| REV | DATE     | DESCRIPTION        | DN | AP |
|-----|----------|--------------------|----|----|
| 8   | 12/11/25 | DA Response        | NC | MF |

SHEET TITLE  
BASEMENT 1 PLAN

PROJECT  
ORAN PARK  
COMMERCIAL 5  
PROJECT  
NO 12

SHEET TITLE  
AREA CALCULATIONS -  
GFA NLA

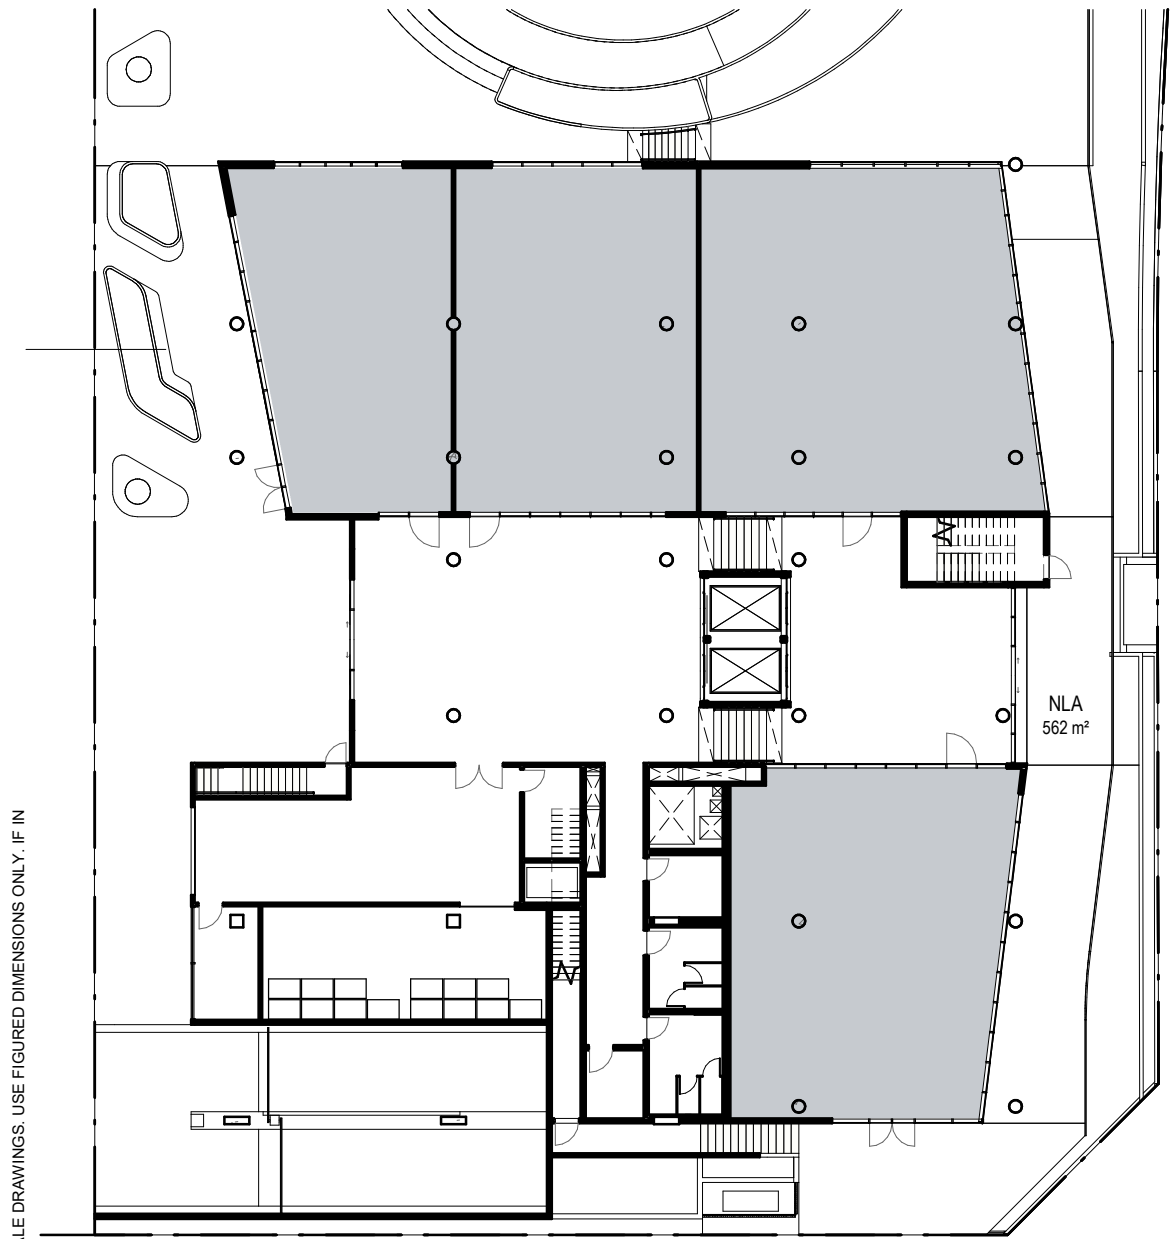
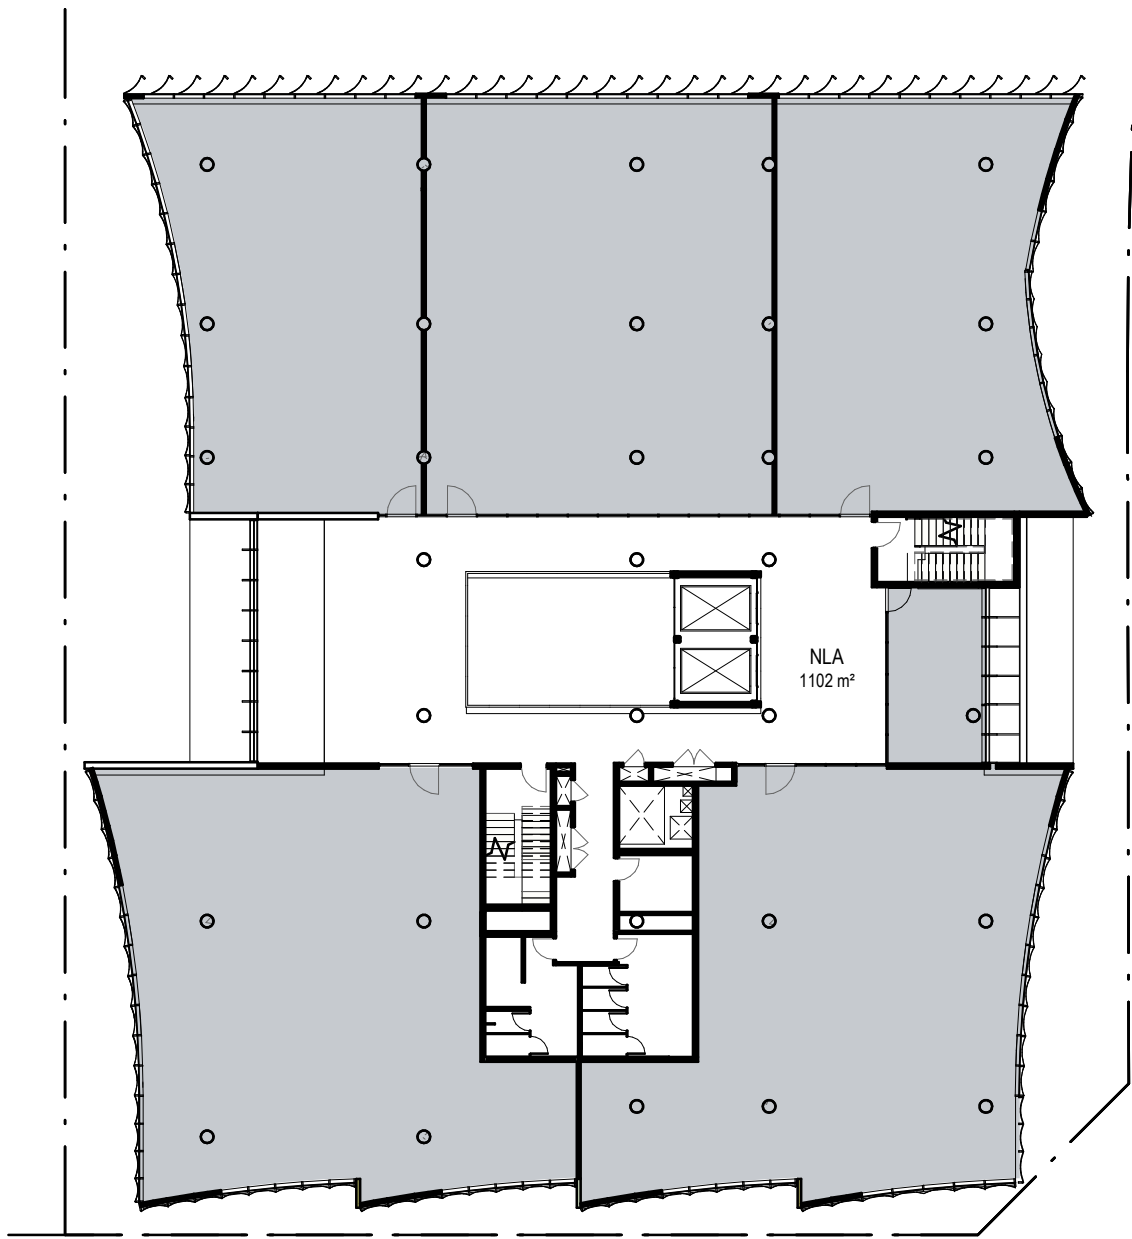
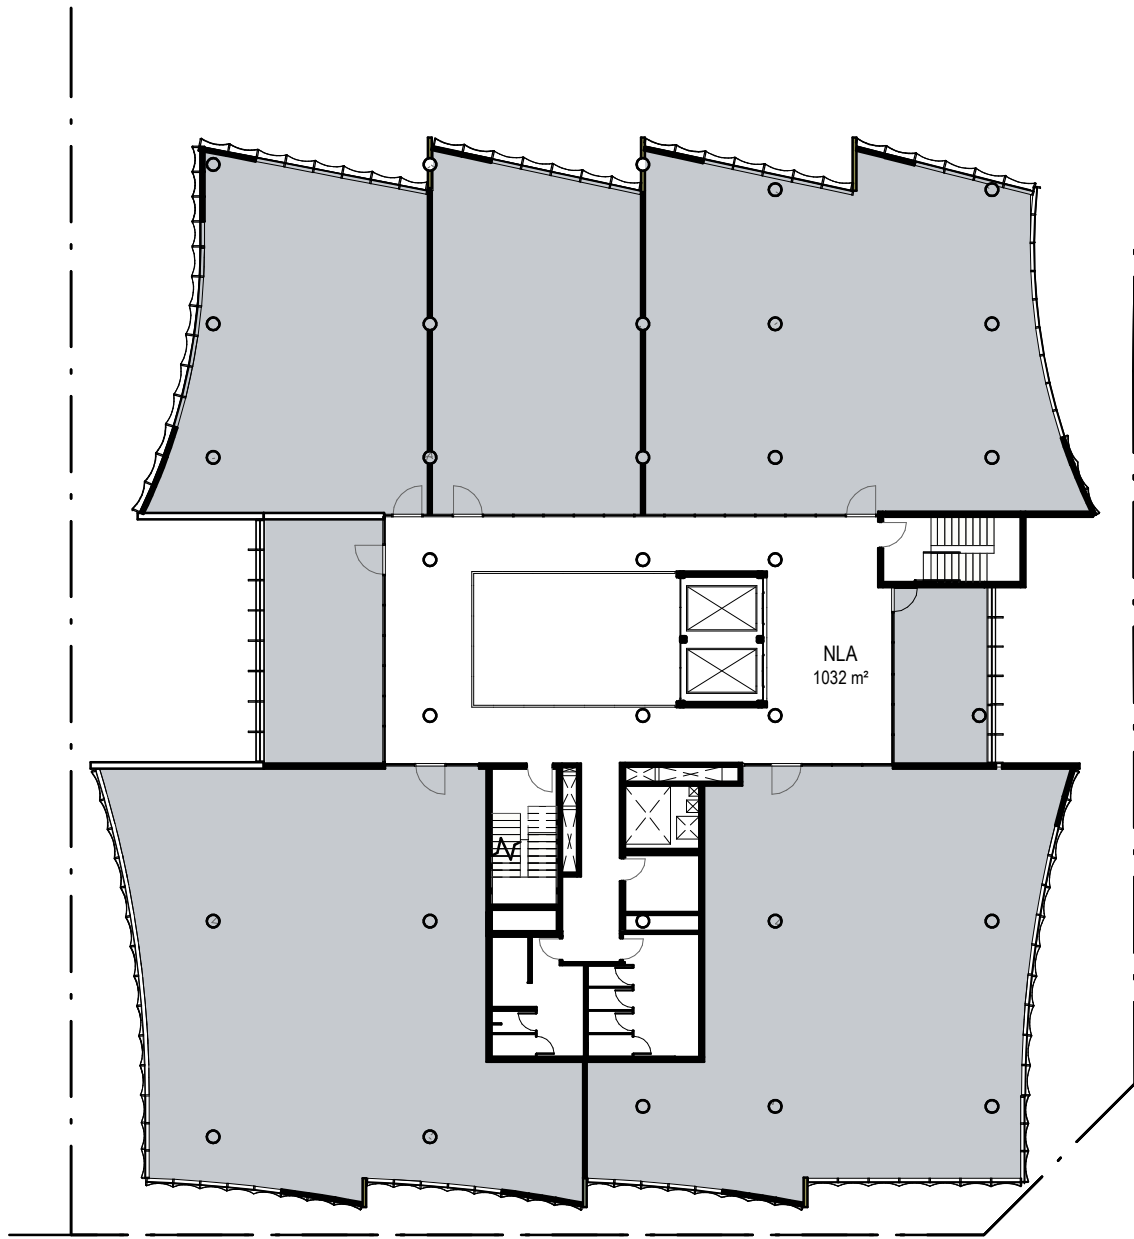
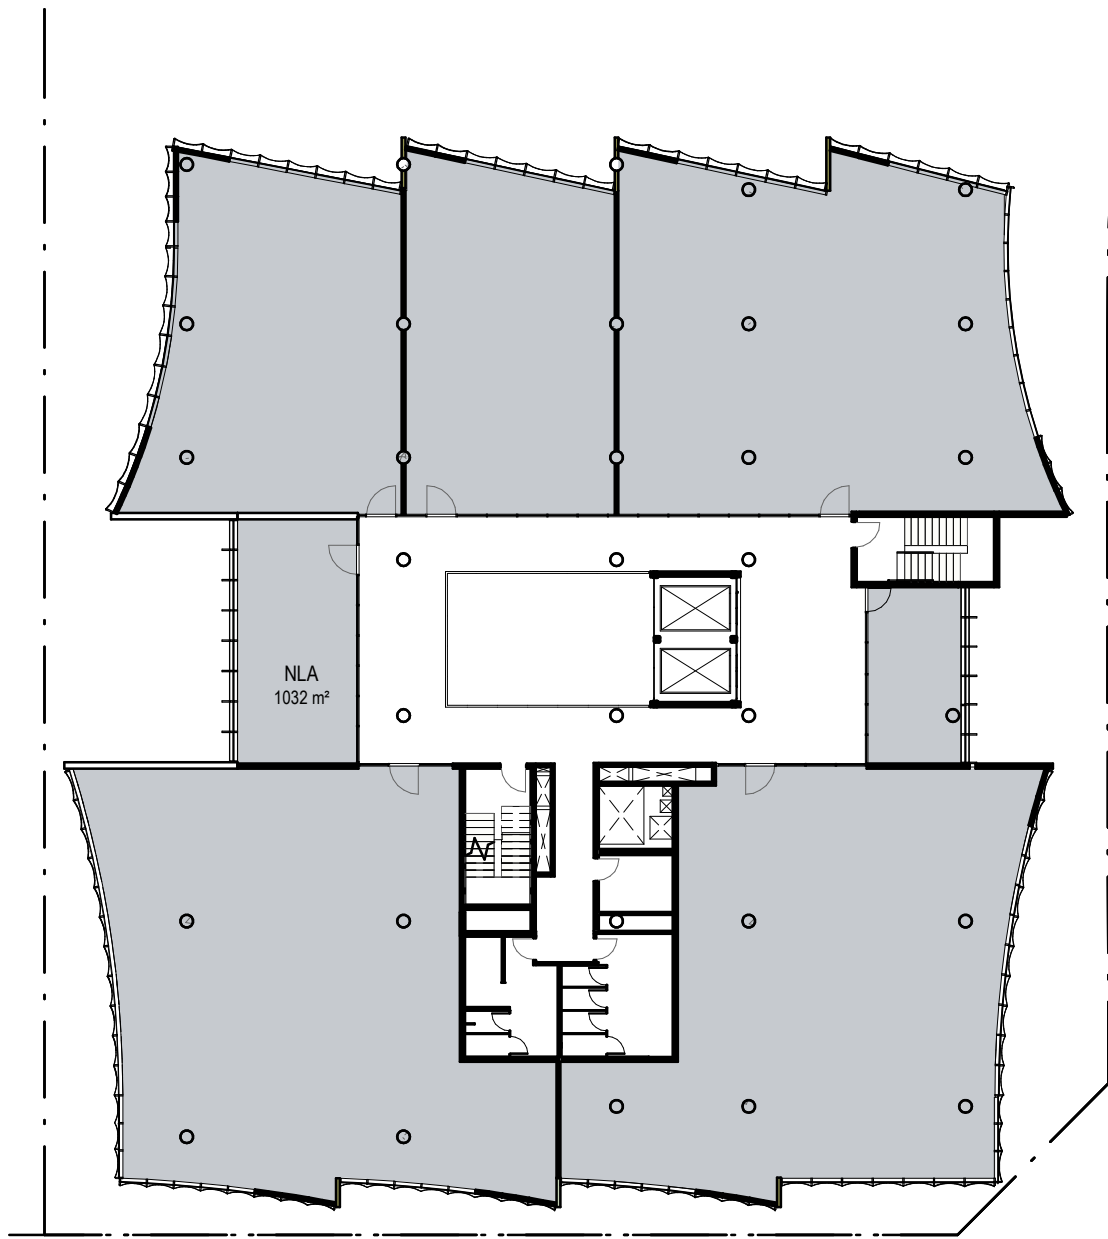
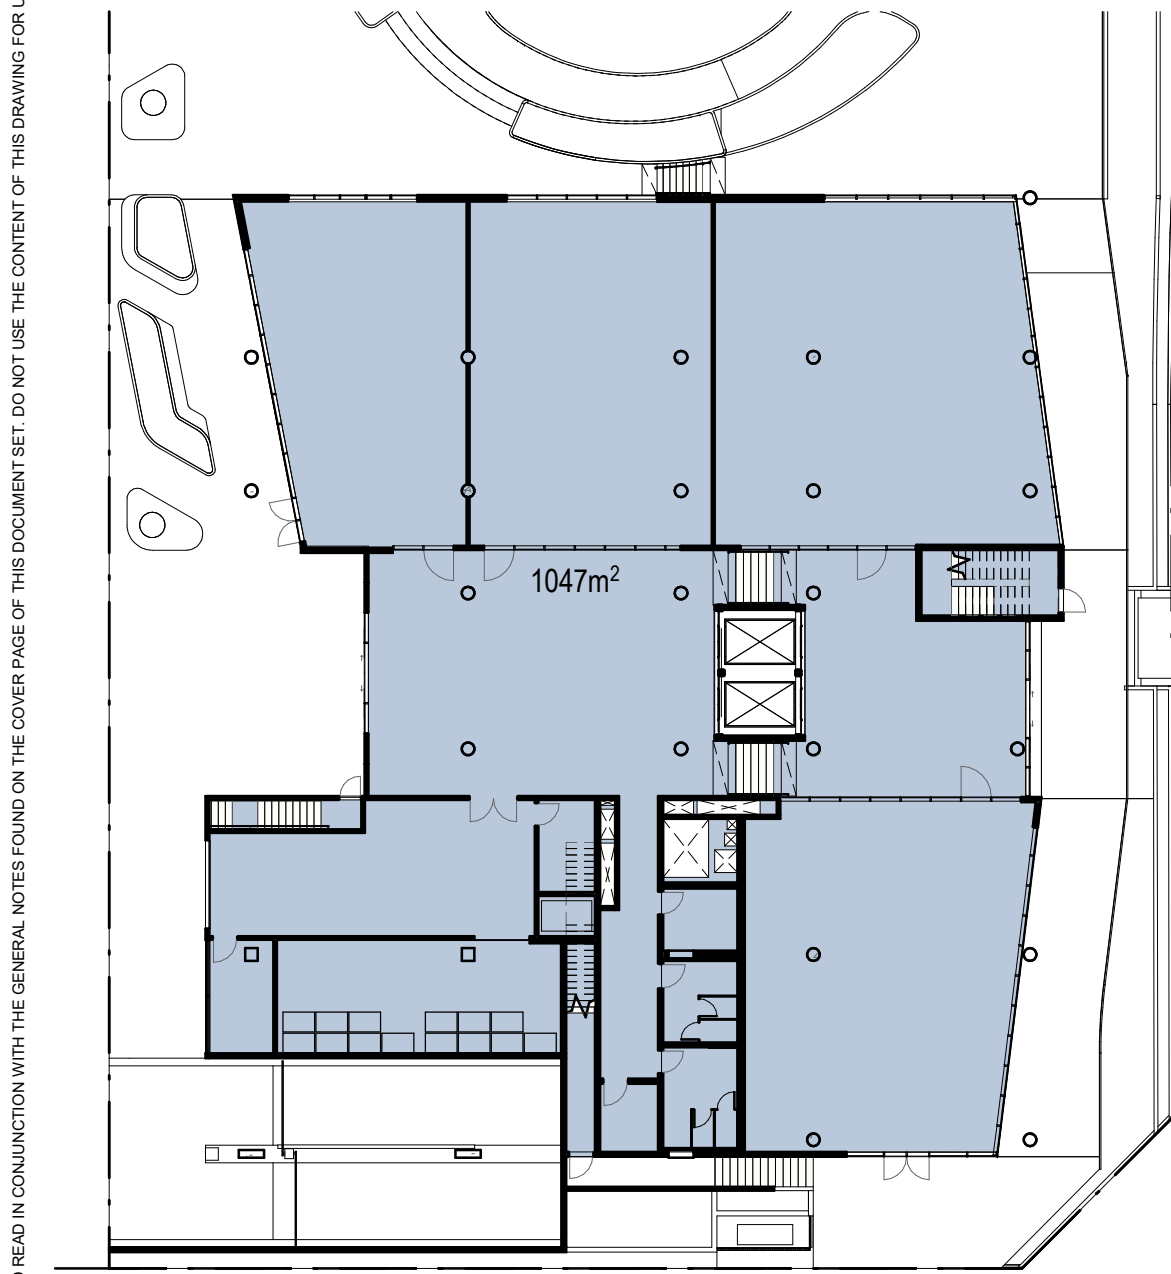
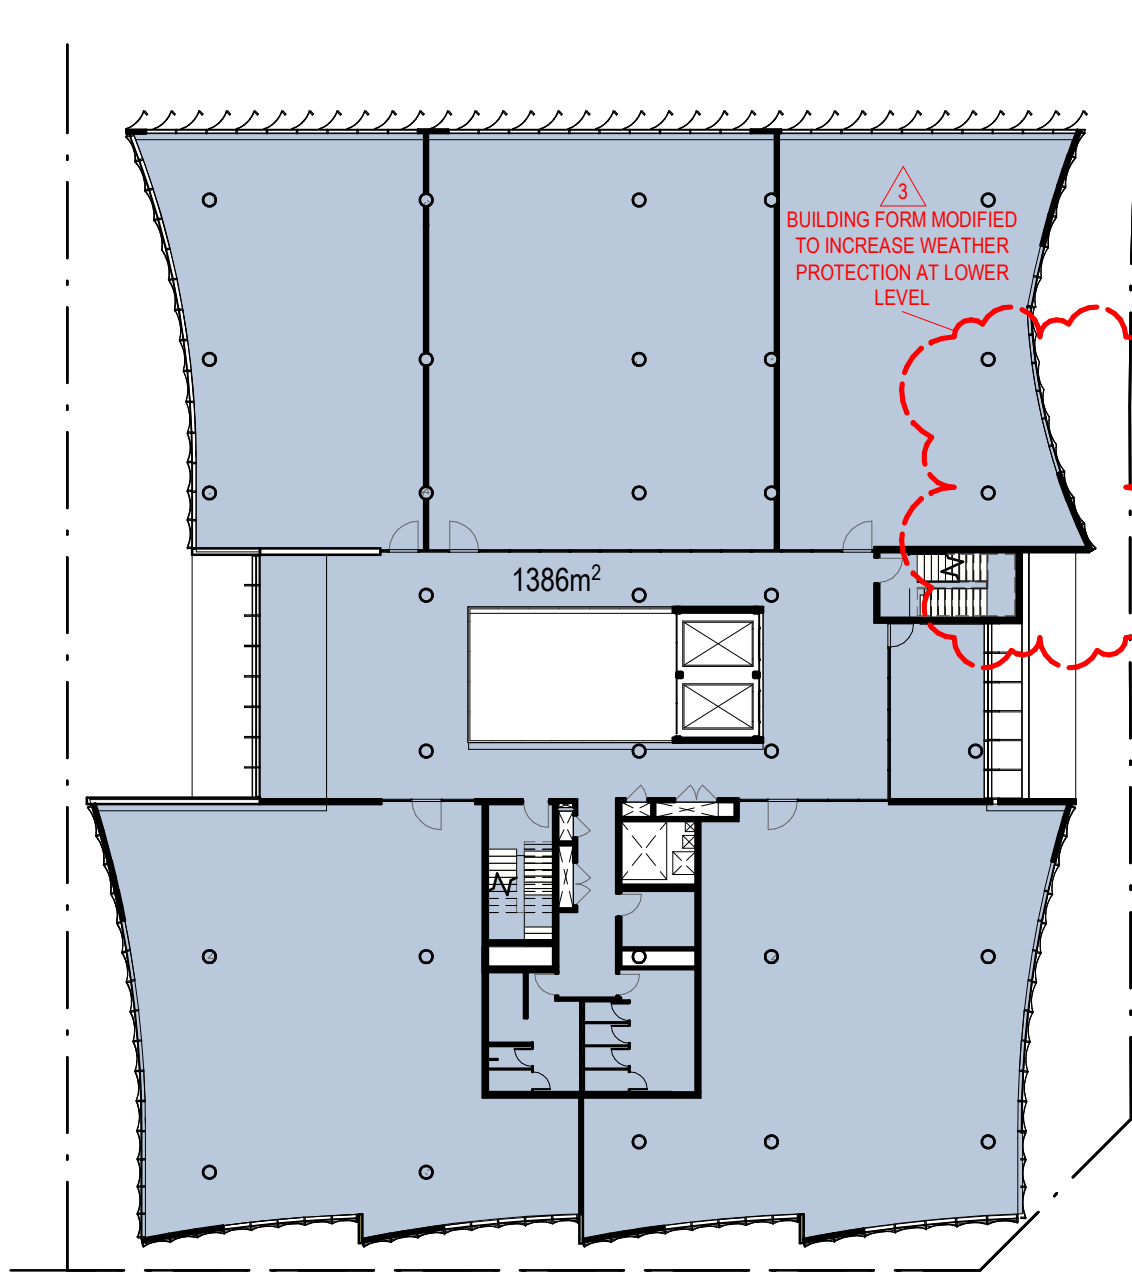
SHEET UPDATED TO  
SEPARATE GFA AND NLA  
AND AREAS UPDATED
